**WOKINGHAM
BOROUGH COUNCIL**

Full Planning Approval Consultation

Application Number: 242189

Site Address: Norton Road Riseley, RG7 1SH

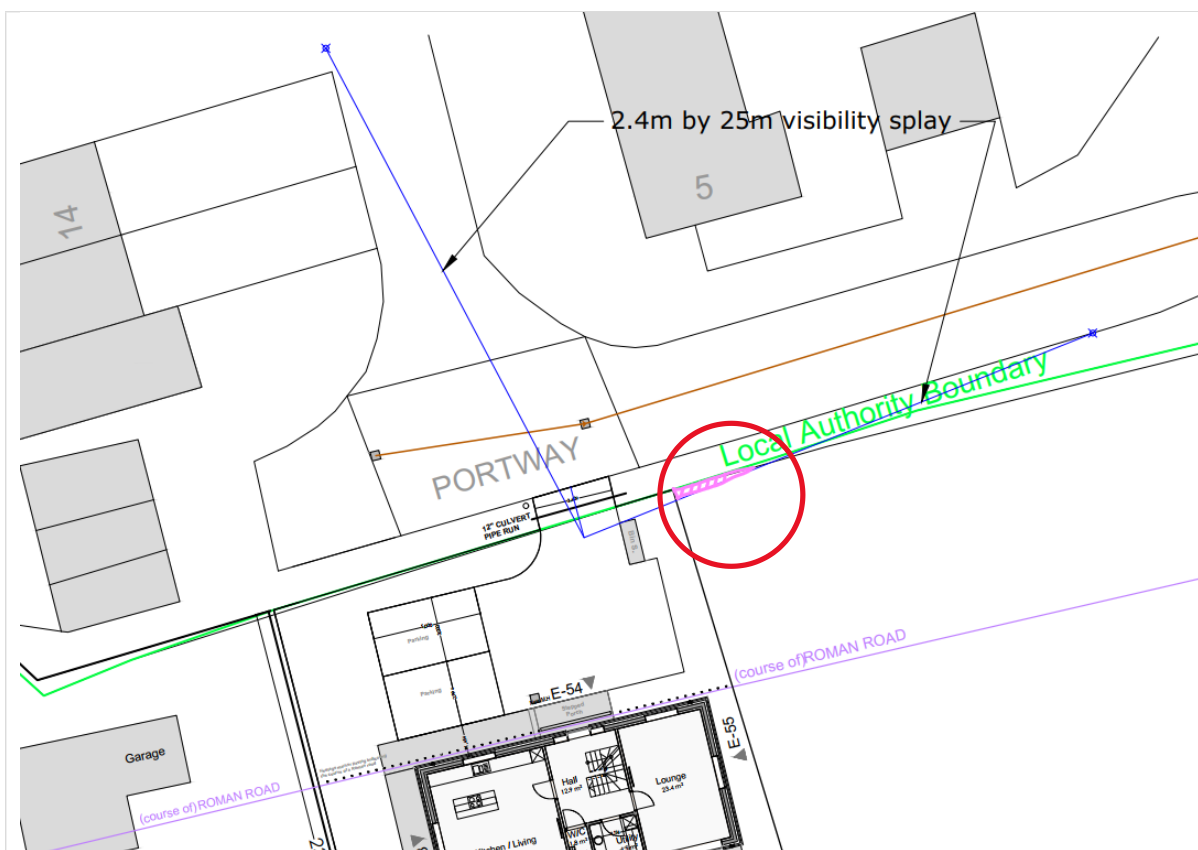
The submitted transport statement contains details of visibility splays to be provided at the access. Although 2.4m x 25m is considered acceptable in principle, the sightline to the east includes land outside of the red line. A revised plan is required to address this (see below, hatched pink).

Subject to a revised plan being received to address visibility splays:
